Memorandum to the City of Markham Committee of Adjustment

File: A/207/23
Address: 111 Grandview Avenue, Markham (Thornhill)
Owner: Brian Lap Yan Tsang
Agent: DIGITECH DESIGNS INC (Andre Grisolia)
Hearing Date: Wednesday, February 21, 2024

The Applicant is requesting relief from the following “Fourth Density Single Family Residential (R4)” zone requirements of By-law 2237, as amended, as it relates to a proposed rear covered cabana. The variance requested is to permit:

DRAWING NUMBER:
SP-1

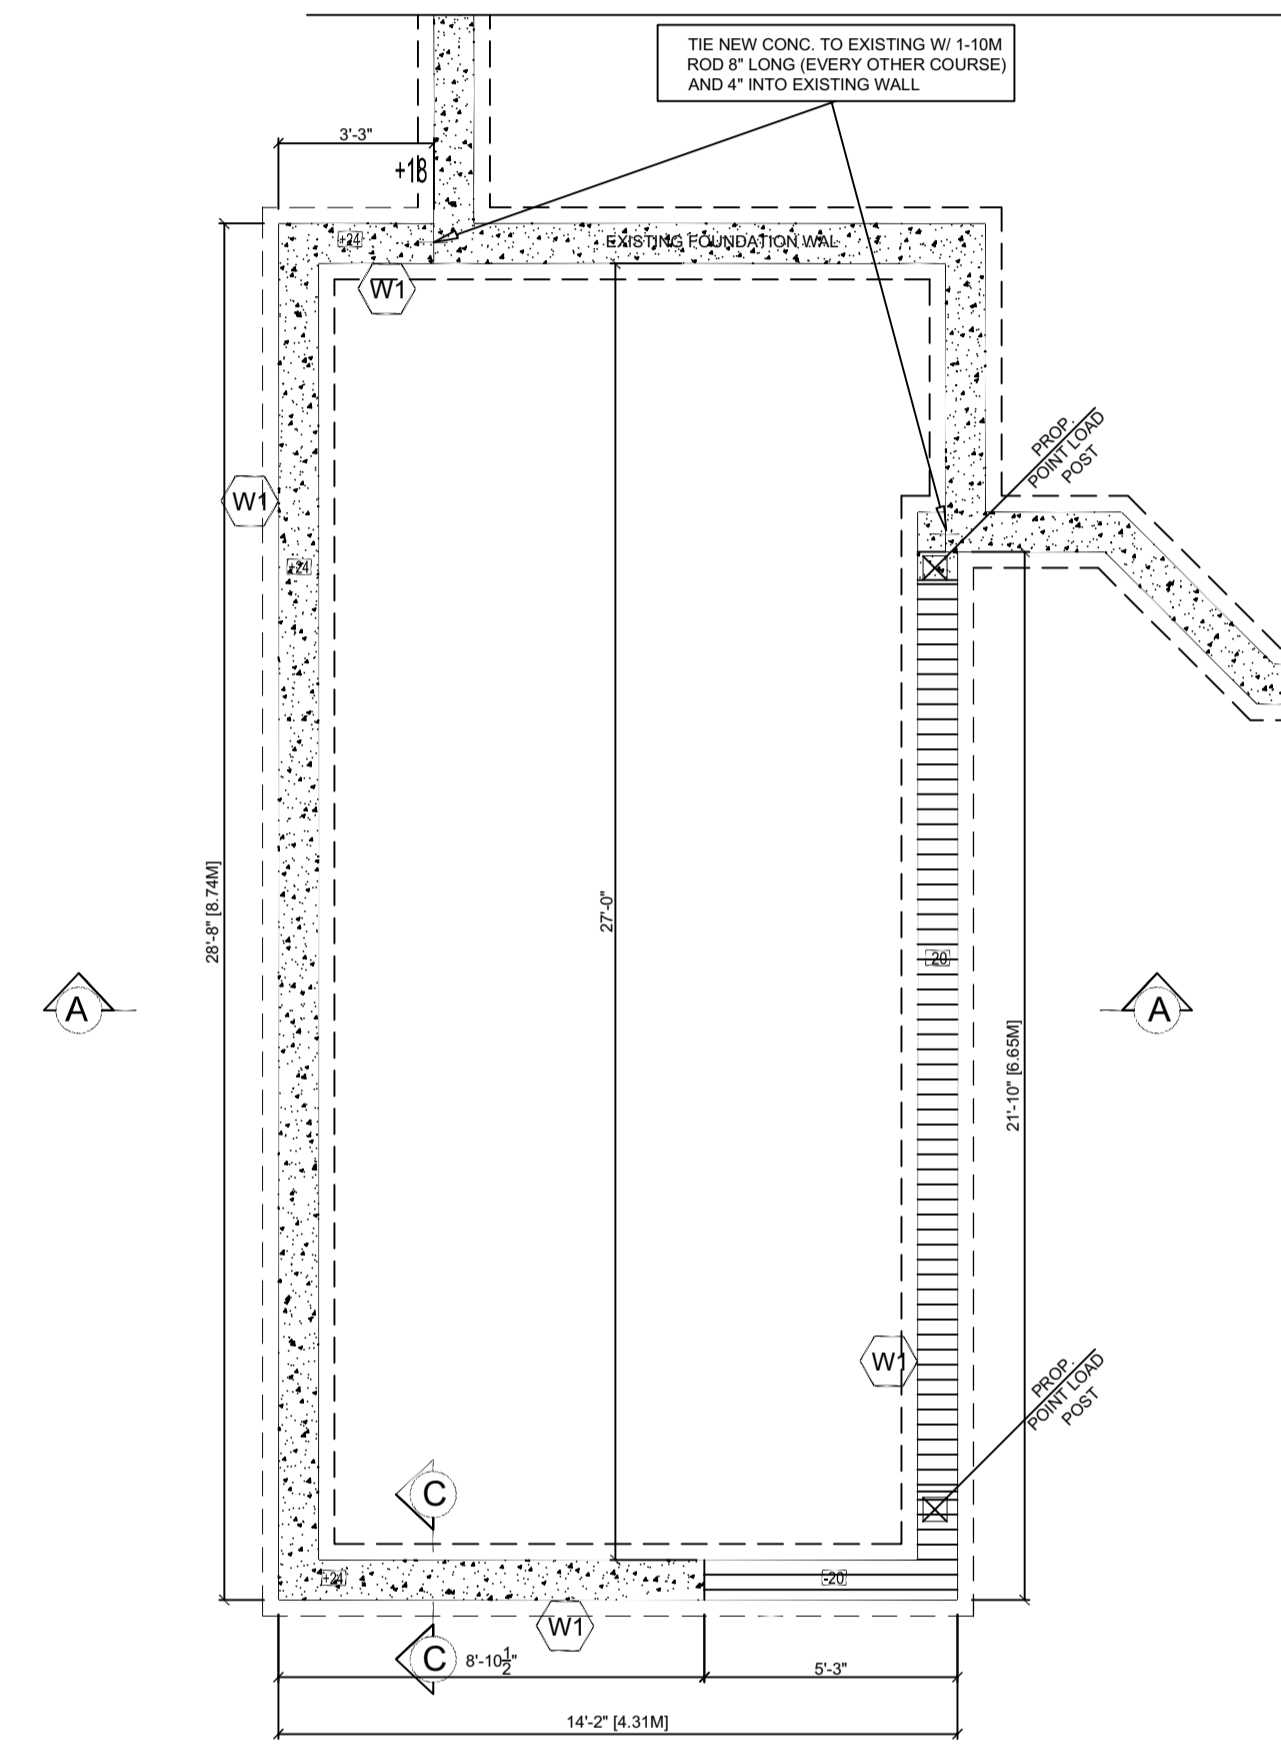
The Applicant is requesting relief to permit a maximum building depth of 20.0 m (65.62 ft), whereas the By-law permits a maximum building depth of 16.80 m (55.12 ft). This represents an increase of approximately 3.20 m (10.50 ft).

Building depth is measured based on the shortest distance between two lines, both parallel to the front lot line, one passing through the point on the dwelling which is the nearest and the other through the point on the dwelling which is the farthest from the front lot line.

The variance includes a rear covered cabana which adds approximately 3.87 m (12.70 ft) to the overall depth of the building. The main component of the dwelling, excluding the front covered porch, has a depth of 16.13 m (52.92 ft), which complies with the By-law requirements. The requested building depth variance is entirely attributable to the proposed rear covered cabana, which provides covered amenity space. Staff are of the opinion that the variance request is minor and therefore have no concern with the requested variance.
